**Applies To:**

All Fusions equipped with carbon reinforced sprog assemblies.

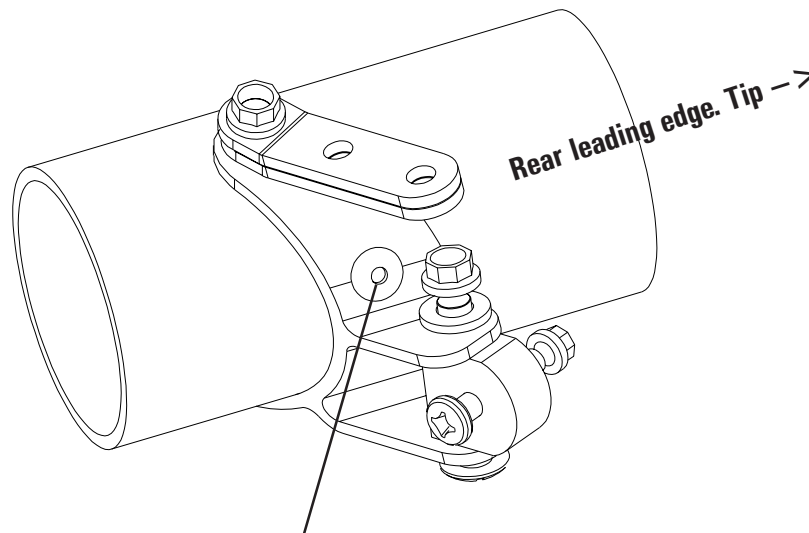
Recently, a Fusion owner performing a routine pre-flight inspection reported that the rivets which secure the orientation of the sprog bracket to the back of the leading edge tube were sheared off. The rivet is essential to the structural integrity of the sprog assembly. The cause of the rivet failure is unknown.

Refer the diagram below. Inspect the rivet fastening the bracket to the backside of the leading edge tube. The 3/16 diameter rivet (part number 10R-0366 Rivet AL 3/16 x .350 Cherry AAPQ6-4) is a high strength 'retained mandrel' type. If the mandrel is missing or the mandrel end is recessed more than 1/16 inches (.063) below the rivet head, the assembly should be considered unairworthy until the rivet is replaced. Replacement rivets are available without charge from Wills Wing. Please include 'Reference TB980709' and your glider number with your request.

**Inspect rivet center for retained mandrel. Replace rivet if mandrel is missing or recessed more than 1/16 inch below surface of rivet dome**
